MARCH 9, 1961

MEMURANDUM REPORT #61.4

REPORT ON THE CURRENT STATUS OF RAPID TRANSIT PLANS FOR THE SAN FRANCISCO BAY AREA RAPID TRANSIT DISTRICT, PARTICULARLY AS THEY CONCERN ROUTES WITHIN SAN FRANCISCO:

RAPID TRANSIT DISTRICT PROPOSALS AUGUST II, 1960

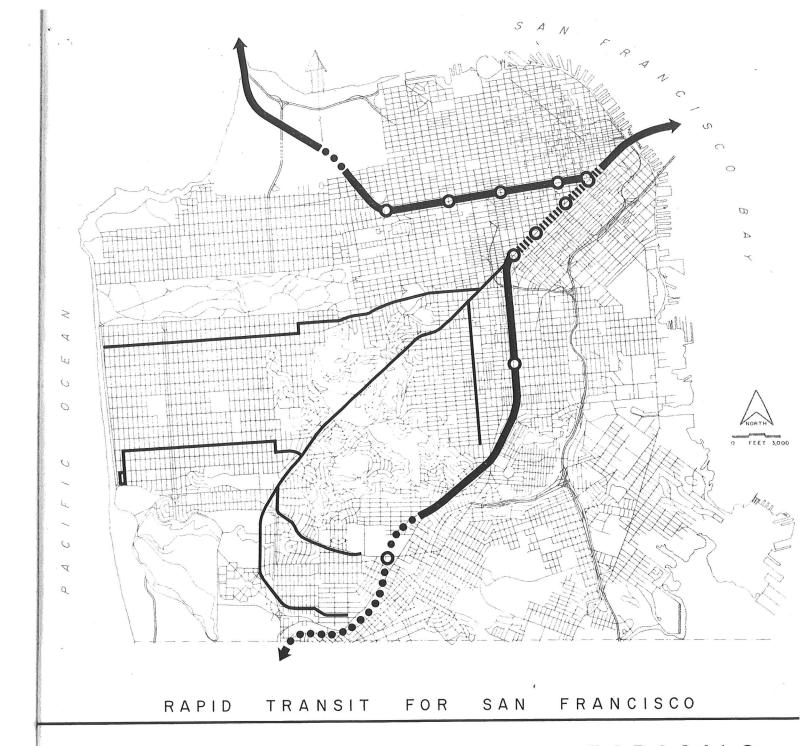
- 1. Elimination of the elevated section on outer Geary Boulevard, and substitution of subway.
- 2. Elimination of San Miguel Tunnel route and substitution of a subway und Mission Street, a tunnel under Chenery Street, and a route in the center division strip of the Southern Freeway southwest of Monterey Boulevard which would allow for stations serving the Mission Street business district and nearby residential areas not possible with the deep long San Miguel Tunnel alignment.

- 3. Extension of the Market Street Streetcar Subway from First Street to Clay and Front Streets adjacent to the Golden Gateway Redevelopment Project area, and from Guerrero Street to the portal of the Twin Peaks Tunnel to provide true rapid transit operating characteristics for the P.C.C. cars now slowed by congested Market Street traffic.

- 4. Changes in downtown station locations and elimination of a continuous pedestrian mezzanine.
- 5. Authorization of a bond issue for the District system sufficiently large to assure the construction in later stages of all routes considered necessary now but curtailed by the Board of Directors of the District because they exceeded the bonding capacity of the District based on present property values (or expected values at the end of the construction period).

- 1. Substitution of Subway for Elevated on Geary Boulevard: In the new plan, the Geary elevated was eliminated by substituting a diagonal tunnel route directly from Post Street and Presidio Avenue to the Golden Gate Bridge. Thus the city's objection was overcome, but the station at Geary Boulevard and Eleventh Avenue was lost in the process.

- 2. Elimination of San Miguel Tunnel and Substitution of a Mission Subway: This change recommended by the city, was adopted as noted above, with the implied proviso that this be obtained without the necessity of expenses to widen the freeway right-of-way.

- 3. Extensions of Upper Level P.C.C. car Subway to Twin Peaks Tunnel and to the Golden Gateway Project. Although the District Board felt these were desirable they did not feel they could be financed by the District in the first construction and financing phase. Thus, they were not adopted for inclusion in the February 9 plans.

- 4. Changes in Downtown Station Locations. These were agreed to. Elimination of the continuous pedestrian mezzanine is to be passed on at a later date when more was known about probable utilization and reaction of nearby merchants.

- 5. Long Range Financing: This was not passed on directly but there were indications that construction should be phased over a longer period of time so that higher later assessment totals could be taken advantage of for a more complete system. Inclusion of later-phase San Francisco projects, such as a Twin Peaks Line or a Bayshore express line was not included in this construction period extension, however.
